MEMORANDUM

To: Design Review Board
From: Scott Guter, AICP, Associate Planner
Date: July 5, 2019
File No.: DRV19-00306
Subject: **KIRKLAND URBAN SOUTH (PHASE 2) PROJECT
DESIGN RESPONSE CONFERENCE**

DESIGN RESPONSE CONFERENCE:
5/24/19

10 Access Street at Southern Property Line - revised diagram

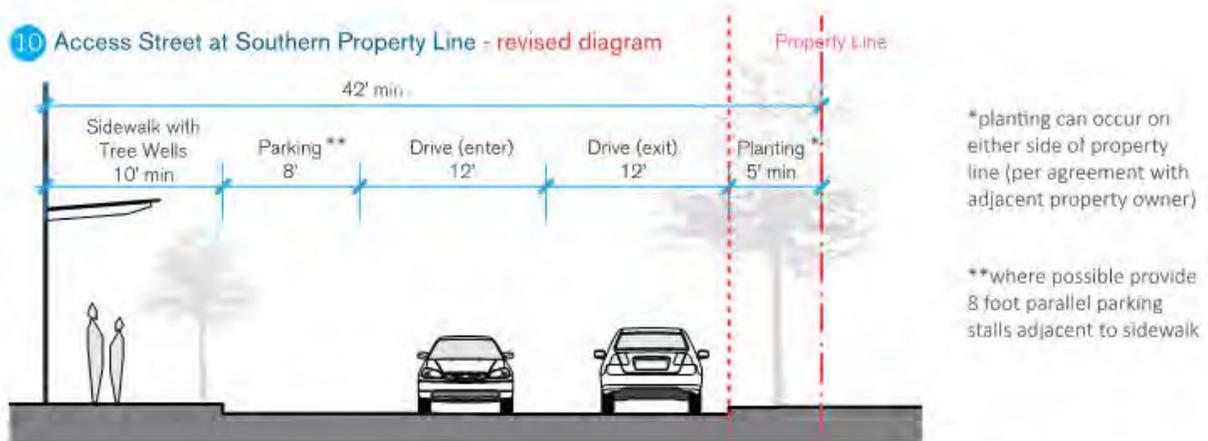
Please refer to the landscape and site plans for dimensions of this roadway. There are slight deviations in the sidewalk width at the northern portion of the theatre frontage to accommodate an accessible ramp. See site plan and landscape plan. In addition, the MRM property to the south (434 Kirkland Way) has shifted their portion of this roadway to the west, leaving an 8 foot sidewalk and no landscape buffer at the west property line. Therefore, the portion of Peter Kirk Lane adjacent to KU South will need to jog to be in alignment. This results in a reduction to the landscape buffer to make the transition of roadway and sidewalk.
